CERTIFICATE OF APPROPRIATENESS

Property: 1720 White St, Tracts 11 and 12, Block 314, Shearn Subdivision. The property includes a historic 1,147 square foot, one-story wood frame single-family residence situated on a 2,950 square foot (47' x 63') interior lot.

Proposal: Alteration – Addition/Windows/Porch

Recommendation: Approval with conditions: Approval with the condition that the applicant (1) retain the historic fenestration pattern on the south side elevation; and (2) hip the addition's roof with a pitch not to exceed 6/12.

SOUTH SIDE ELEVATION

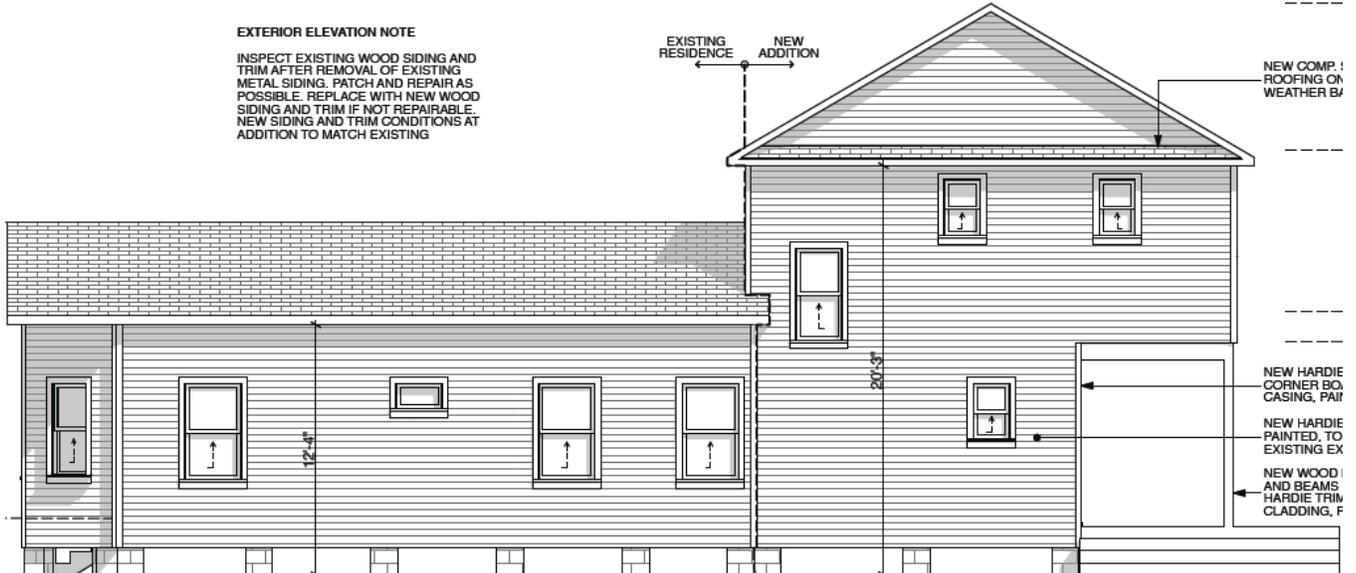
HAHC Action: Approved with Conditions: Approved with the condition that the applicant retain the first two window openings on the south side elevation closest to the front (west) elevation.

<i>Altering the original fenestration pattern on the south elevation of the existing residence does not retain or preserve the historical character of the property because it disrupts the existing solid-to-void pattern indicative of early structures.
The addition's gable roof overpowers the existing residence creating a significant visual impact. The gable roof is not compatible with the existing residence's simple massing, and therefore does not retain or preserve the historical character of the property.</i> |

<i>Altering the historic fenestration pattern on the south elevation of the existing residence creates a later appearance by disrupting the existing solid-to-void pattern indicative of early structures.</i> |

<i>In addition to altering the historic fenestration pattern on the south elevation, the applicant proposes to increase the size of the existing openings which will require extensive reframing, resulting in a loss of historical and architectural material.</i> |

EXISTING RESIDENCE NEW ADDITION

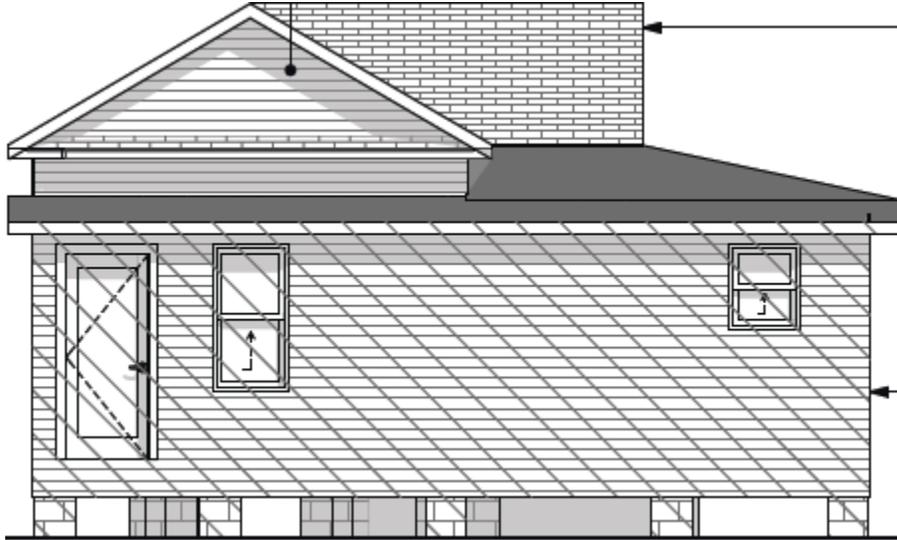
<i>Altering the original fenestration pattern on the south elevation of the existing residence does not preserve the distinguishing qualities or character of the building.
The addition's gable roof overpowers the existing residence creating a significant visual impact. The gable roof is not compatible with the existing residence's simple massing, and therefore does not preserve the distinguishing qualities or character of the building.</i> |

- (10) The proposed alteration or addition must be compatible with the massing, size, scale material and character of the property and the context area; and
*Altering the original fenestration pattern on the south elevation of the existing residence disrupts the existing solid-to-void pattern indicative of early structures, and therefore is not compatible with the character of the property.
The addition's gable roof is disproportionately massed in comparison to the existing residence, and is therefore not compatible with the simple massing of the building.*
